THARP 44D-14-692

Draft Observations:

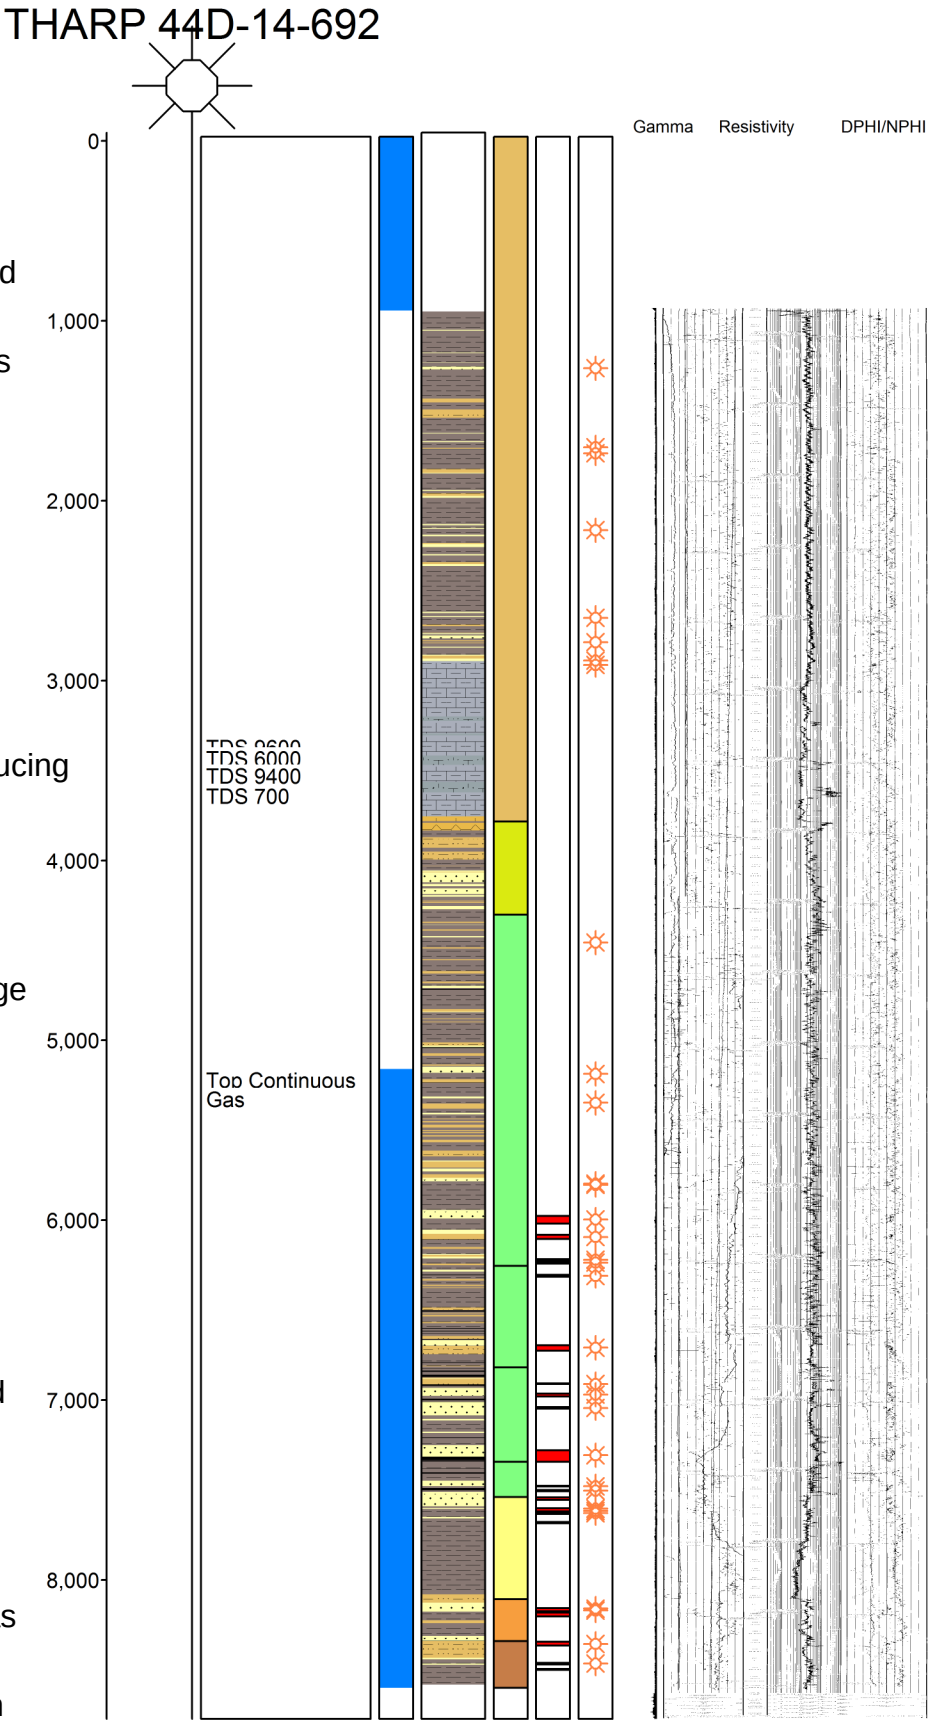
1.) There is open bradenhead annulus from 900 ft to 5170 ft. Top of cement and good bond are concurrent.

2.) Bradenhead annulus is open to Williams Fork, Ohio Creek, and Wasatch formations.

3.) Gas shows in the Wasatch and Williams Fork formations are in contact with open bradenhead annulus.

4.) The well is not producing gas shows above the top of cement.

5.) The calculated TDS values in the lower Wasatch formation range from 700 to 9600 mg/l.

6.) The August 2010 drilling completion report specified the 72 hour bradenhead pressure as 0 psig; however, a notice to vent or flare was subsequently submitted in 2010. The 2013 and 2014 bradenhead pressure test reports recorded the final bradenhead pressure as 0 psig.

7.) The 2014 inspection report did not specify if the well was venting or not.

Is the well venting?

Why did the operator submit a notice to vent if the bradenhead pressure test recorded a final bradenhead pressure of 0 psig?
